PUBLIC INTEREST REVIEW FOR GROUND WATER APPLICATIONS

TO: Water Rights Section Date December 3, 2015
 FROM: Ground Water/Hydrology Section K. Lite
Reviewer's Name
 SUBJECT: Application G- 18103 Supersedes review of N/A
Date of Review(s)

A. GENERAL INFORMATION: Applicant's Name: Justensen Brothers County: Wasco

A1. Applicant(s) seek(s) 1.51 cfs from 1 well(s) in the Deschutes Basin,
White River subbasin Quad Map: Postage Stamp Butte

G-18103: Postage Stamp Butte and Tygh Valley Quadrangles

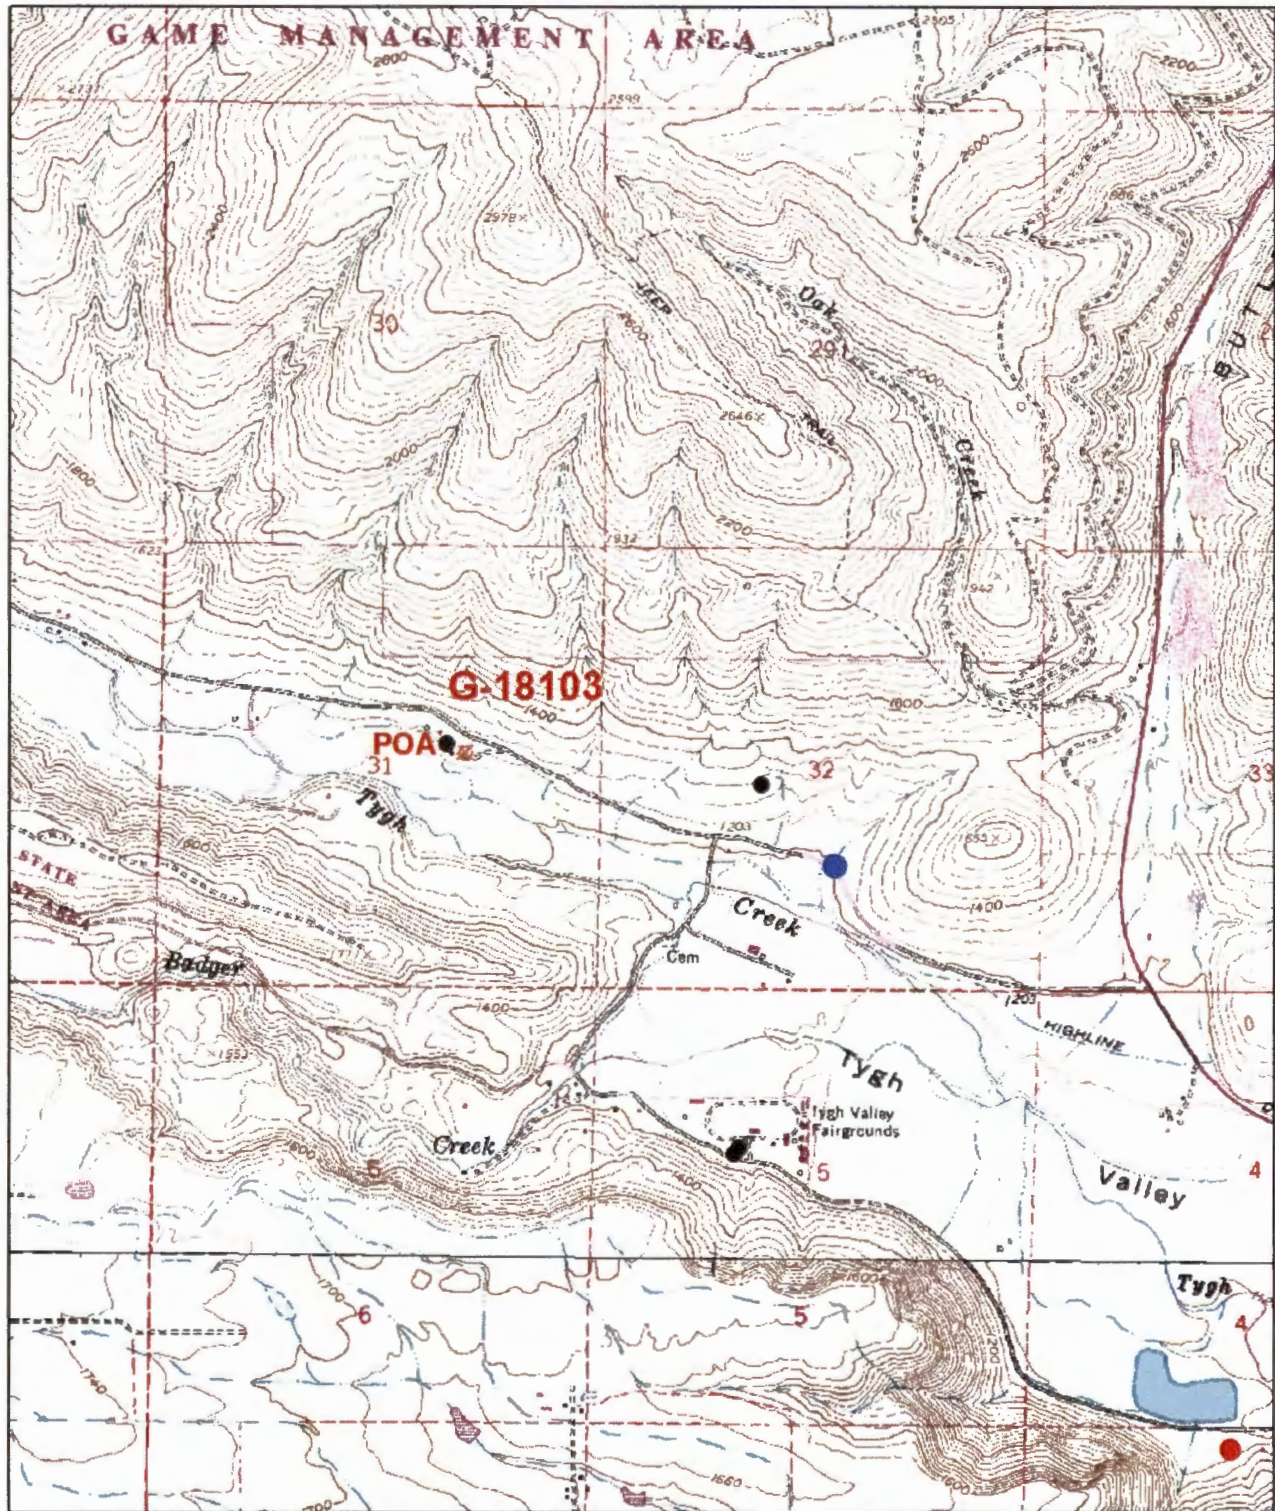
A4. **Comments: POA location on application map is slightly off (250' southeast of) the actual (OWRD GPS) location. Volcaniclastic sediment dips steeply (40-45 degrees) to the south.**

Water level data have been periodically measured and submitted for a well in the same vicinity. The well (Wasc 51079) is also likely constructed into the same geologic unit as the proposed poa. Water level data submitted for Wasc 51079 on Permit G-16379 shows a water level decline of approximately 72 feet between April 2009 and February 2013, and a recovery of 46 feet between February 2013 and February 2015.
